RE: Windfall Oil & Gas, Inc.
Permit # PAS2D020BCLE
PERMITTED FACILITY: Class II-D injection well, Zelman #1

PETITION FOR REVIEW

1: Overpressuring the Long String Casing Annulus

Attachment "M"
 Construction Details - subsurface
 Zelman#1 Injection Well
ZELMAN WELLBORE SCHEMATIC

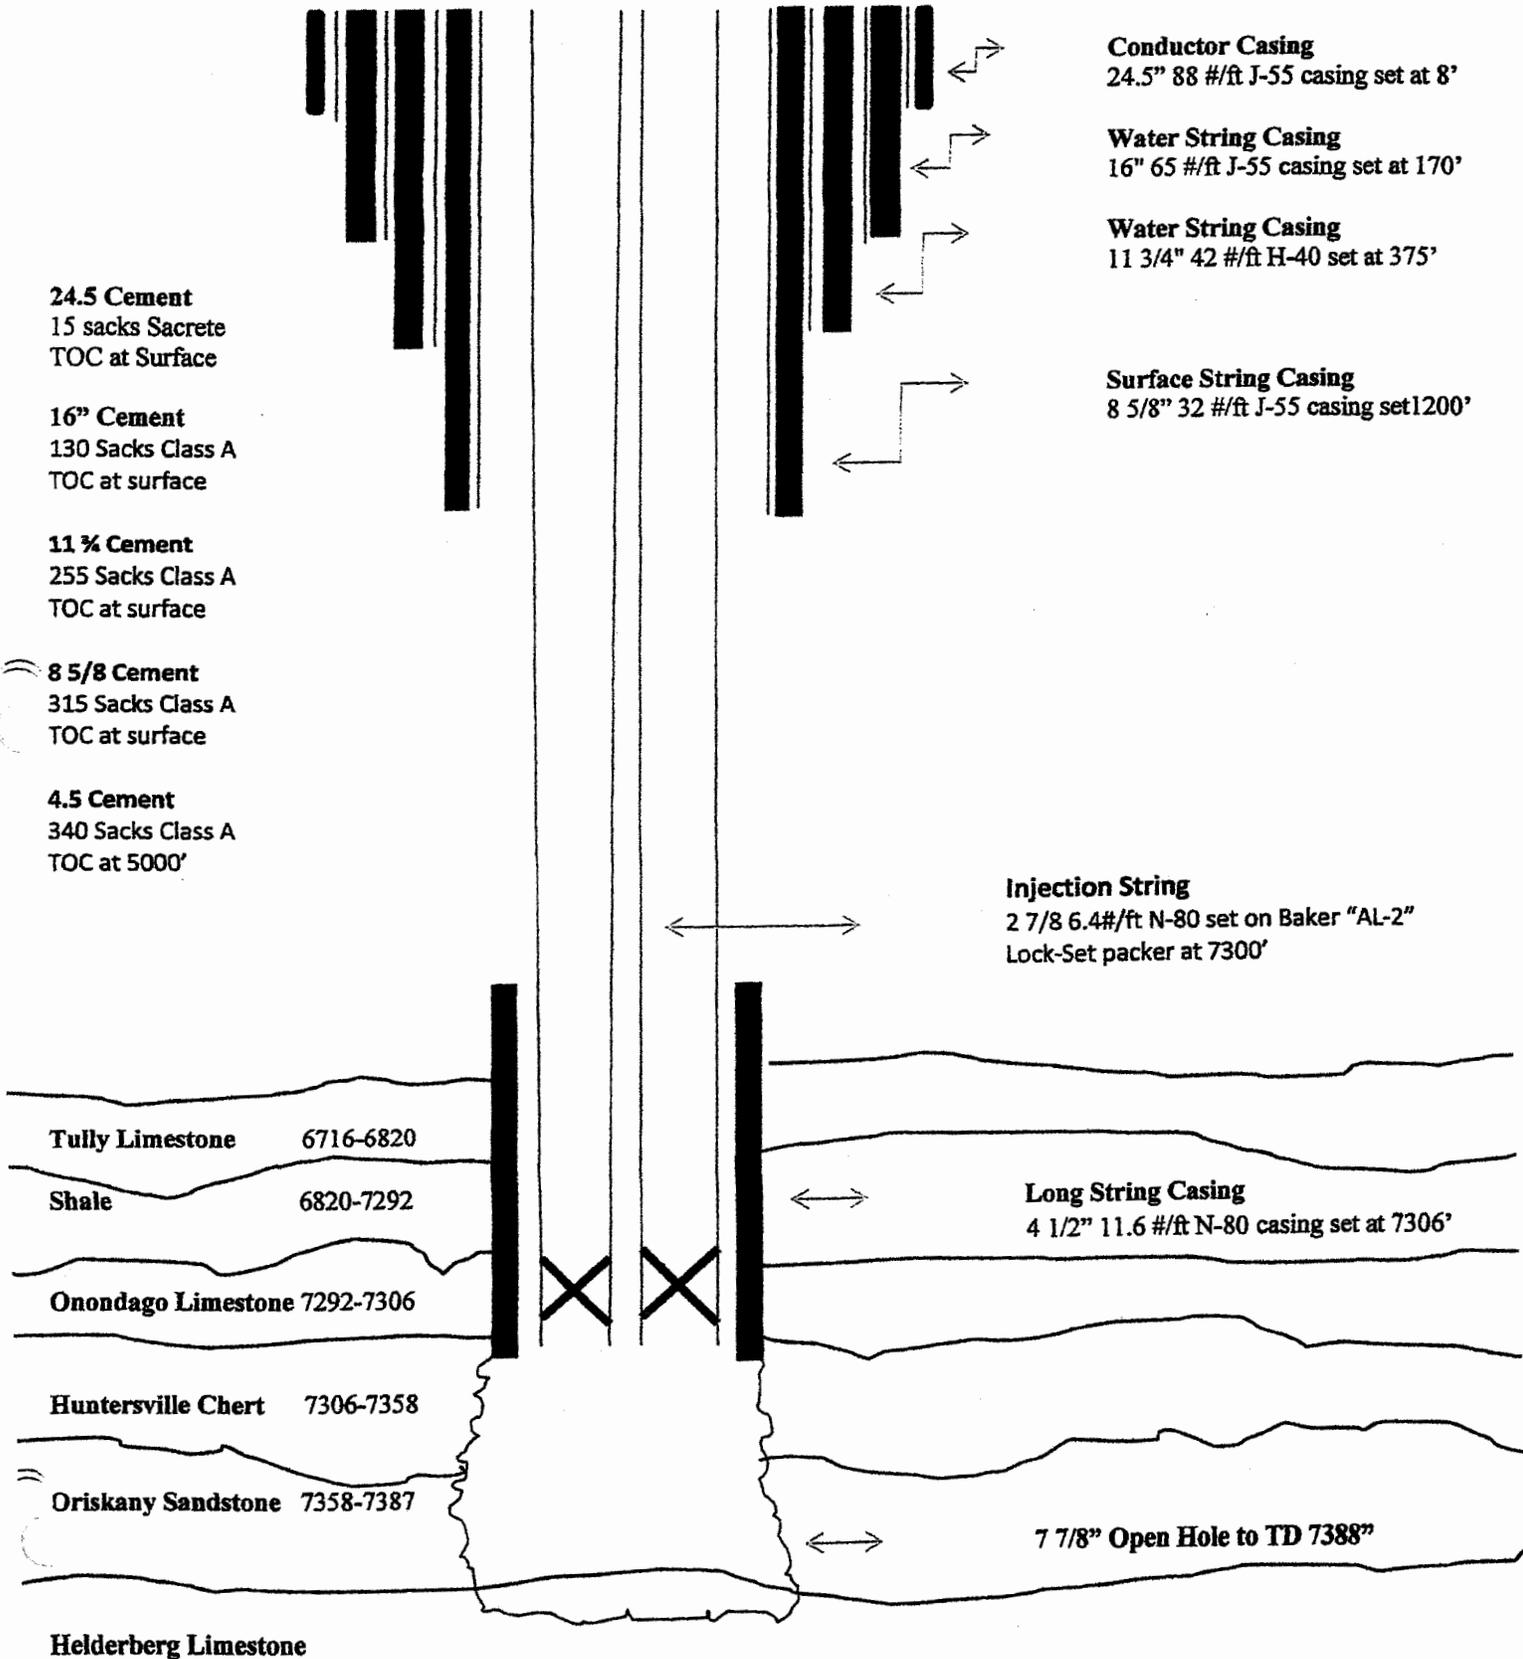
4. Should the cement sheath at the bottom of the long string casing be extended above the 5000 foot level? A recent NETL report concluded that the Tully Limestone is not always a reliable fracture barrier for horizontal Marcellus gas wells.

5. Should there be an intermediate casing installed so that the long string casing can have a cement seal the whole way up to the surface casing?
6. Should there be a means to pump liquid out of the open annulus between the surface casing and the long string casing above 1000 feet?

ZELMAN WELLBORE SCHEMATIC (MODIFIED)
BY RLA

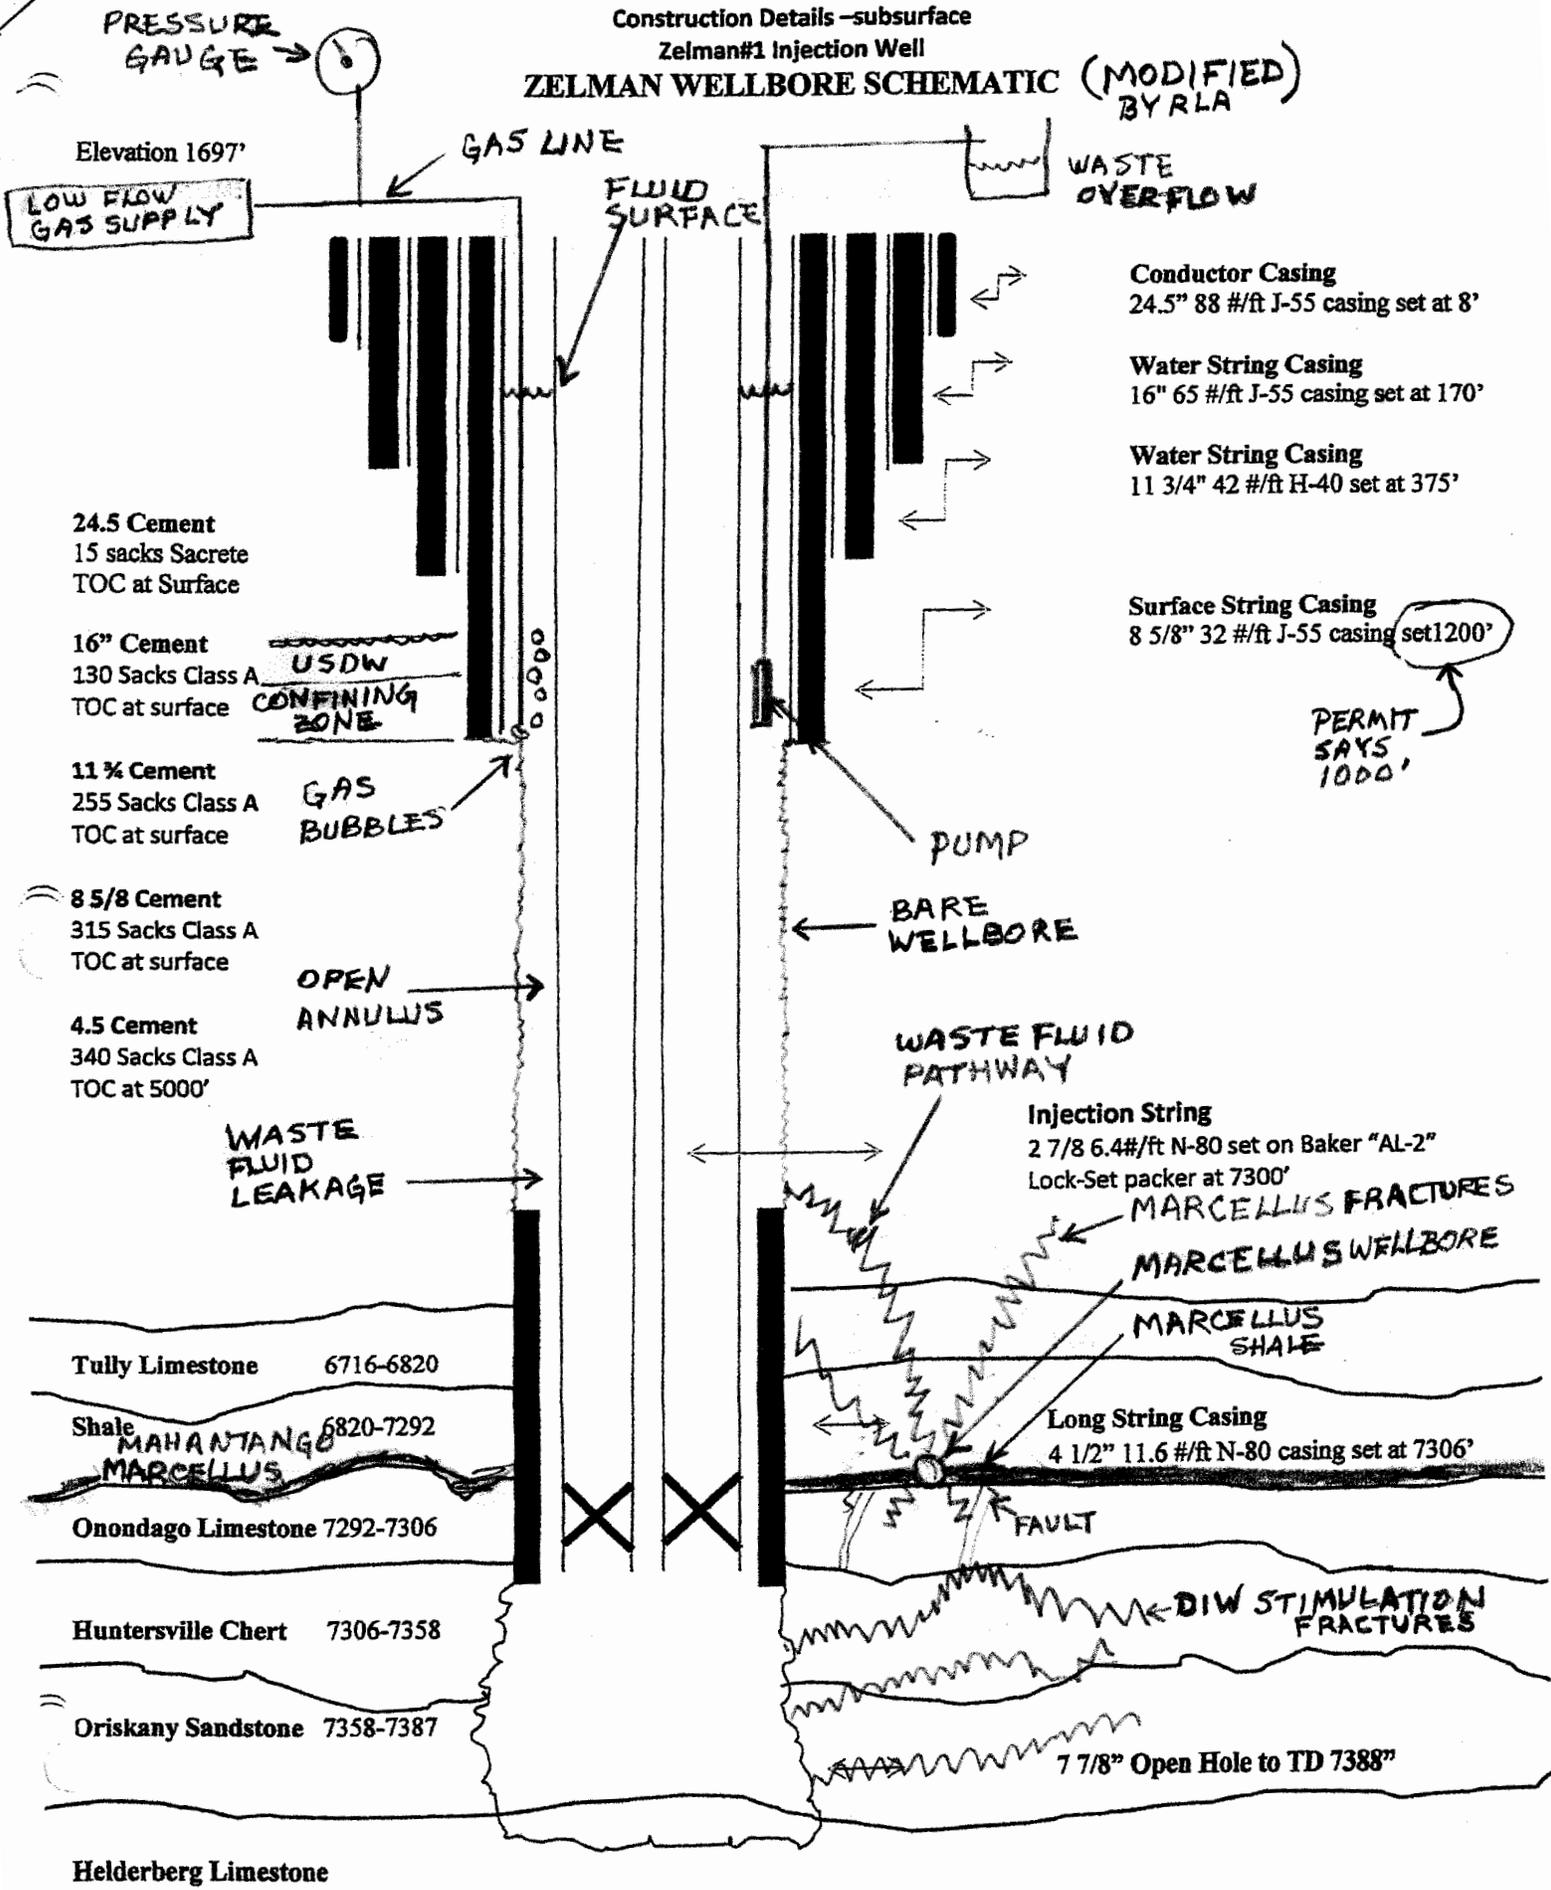
The requirements for constructing the Windfall disposal injection well allow for an open annulus between the wellbore and the 4 ½" diameter long string casing. The open annulus begins at the top of the cement sheath around the long string casing, at 5000 feet deep, and extends upward to the bottom of the cement sheath around the surface casing, at 1000 feet deep, and then up through the inside of the surface casing to ground level.

The permit mentions no provision for venting the open annulus or capturing any fluid that may flow out of the open annulus at the wellhead. Allowing pressure buildup caused by closing off the annulus would be very risky.

The open annulus has a volume that is most likely less than 600 barrels. The pressure required to lift waste fluid with a specific gravity of 1.26 from the top of the long string casing cement, at 5000 feet, to surface level is 2730 psi. This is less than half of the maximum allowable injection pressure of 6425 psi.

Suppose that 1% of the injected waste fluid is able to leak into the open annulus at a reduced pressure that exceeds 2730 psi. The limit on the rate of disposal is 30,000 barrels per month. In 2 months the annulus could be filled.

The open annulus outside of the long string casing penetrates the ultimate confining zone adjacent to the lowermost USDW, which is at about 800 feet deep. Below 1000 feet, the annulus is exposed to the bare rock layers of the wellbore. Above 1000 feet, the annulus is sealed from the rock of the wellbore by a surface casing with a cement sheath.

WASTE
FLUID
LEAKAGE

PERMIT
SAYS
1000'

WASTE FLUID
PATHWAY
